# UNITED STATES PATENT AND TRADEMARK OFFICE

APPLICATION NO.	FILING DATE	FIRST NAMED INVENTOR	ATTORNEY DOCKET NO.	CONFIRMATION NO.
10/567,891	02/08/2006	Henning Von Spreckelsen	FIL-001	7288
22832	7590	06/08/2010	EXAMINER	
K&L Gates LLP STATE STREET FINANCIAL CENTER One Lincoln Street BOSTON, MA 02111-2950			HYLTON, ROBIN ANNETTE	
			ART UNIT	PAPER NUMBER
			3781	
			MAIL DATE	DELIVERY MODE
			06/08/2010	PAPER

### Office Action Summary

**DETAILED ACTION**

FIG. 3

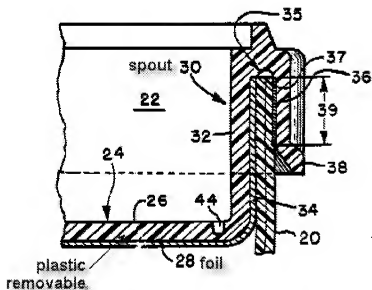
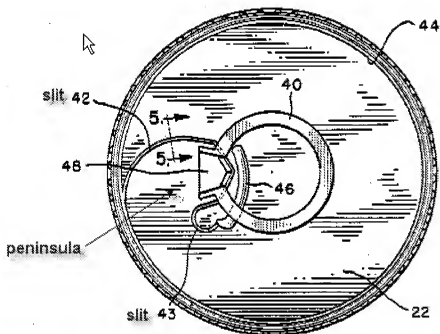
MacLaughlin discloses a closure comprising a spout defining an opening, a removable plastic part (26) disposed over the opening and connected to the spout by a frangible region

(44), the removable part including a peninsula formed between the frangible region and a slit (42,43) that divides the removable part and extends into the removable part from an edge of the removable part; a tearable seal (28) disposed across the opening and attached to the peninsula; a pull ring (40); and a leg (48) connecting the pull ring to the peninsula; wherein the seal is torn when a force applied to the pull ring is concentrated onto the peninsula, and wherein the leg is connected to the peninsula at a periphery of the removable part. Wherein the removable part is removable and has a slit and frangible portion it meets the claims.
